**City of Bellevue  
Development Services Department  
Land Use Staff Report**

**Proposal Name:** Sai Short Plat

**Proposal Description:** Preliminary Short Plat approval to subdivide an existing parcel into two single family lots within the R-5 zoning district.

**File Number:** 15-130120-LN

**Figure 1 – Preliminary Short Plat Proposal**

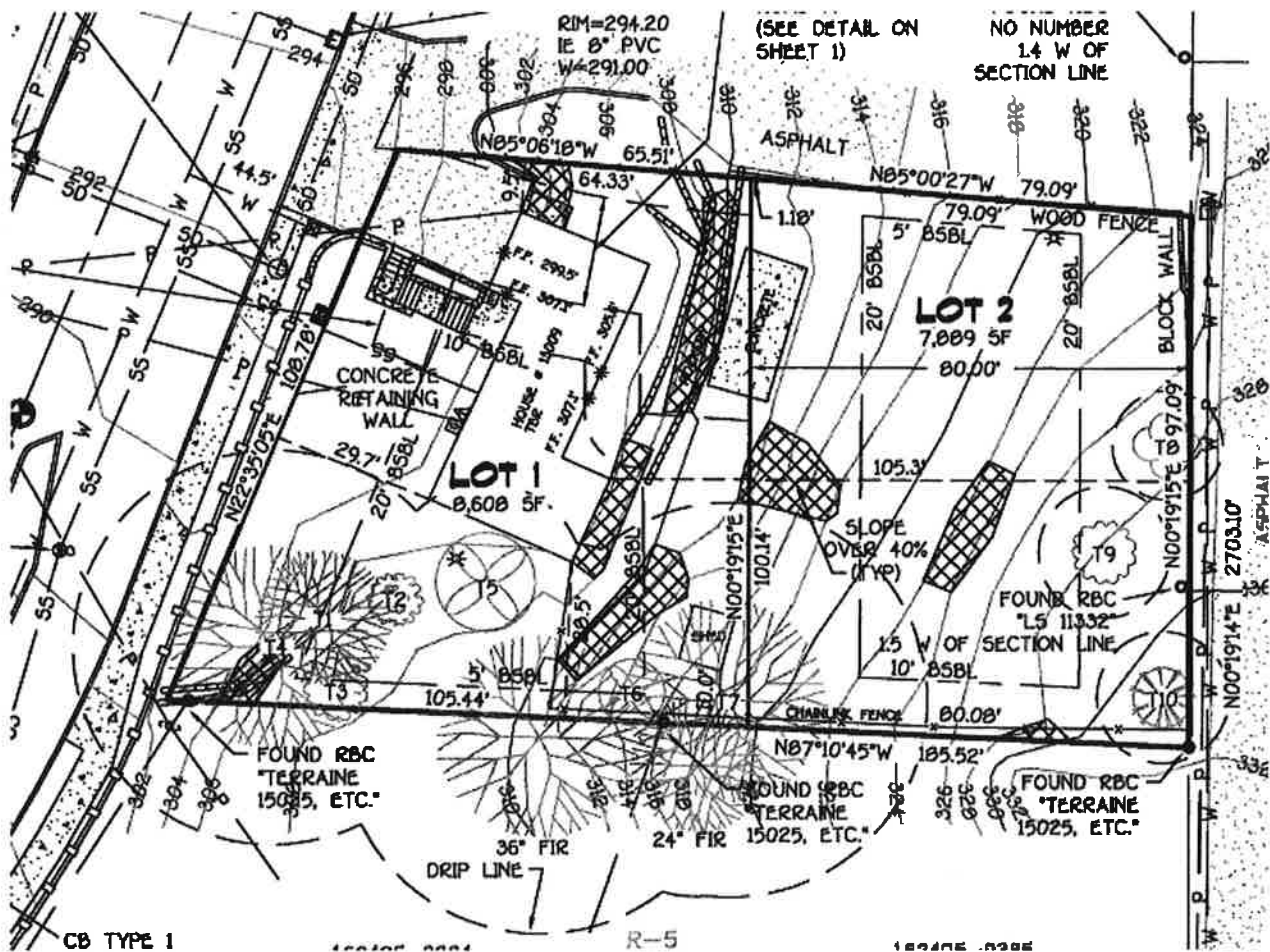
The original design was revised to retain more significant trees and retaining walls were modified to limit disturbance.
